**Information technology — MPEG
audio technologies —**

Spatial Audio Object Coding (SAOC)

AMENDMENT 3: Dialogue enhancement

Reference number
ISO/IEC 23003-2:2010/Amd.3:2015(E)

Figure 13 — Basic structure for the SAOC transcoding/decoding modes

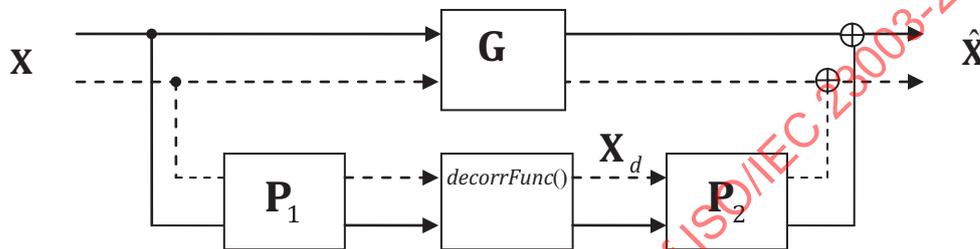
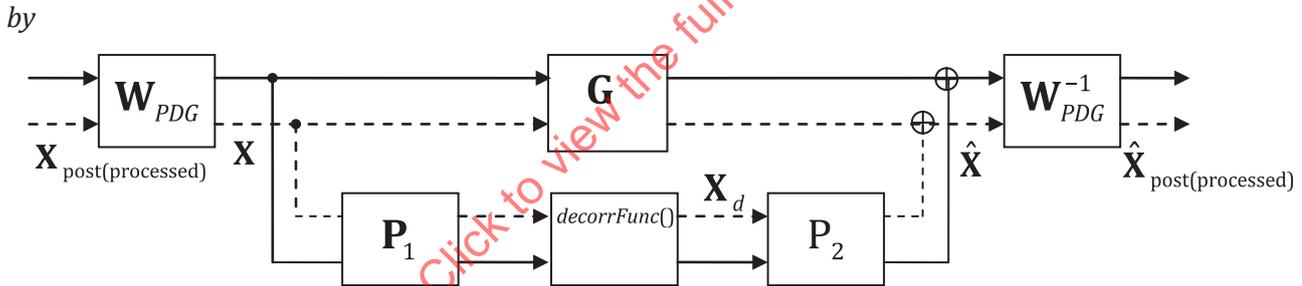
Replace in "SAOC transcoding/decoding modes" the following figure:
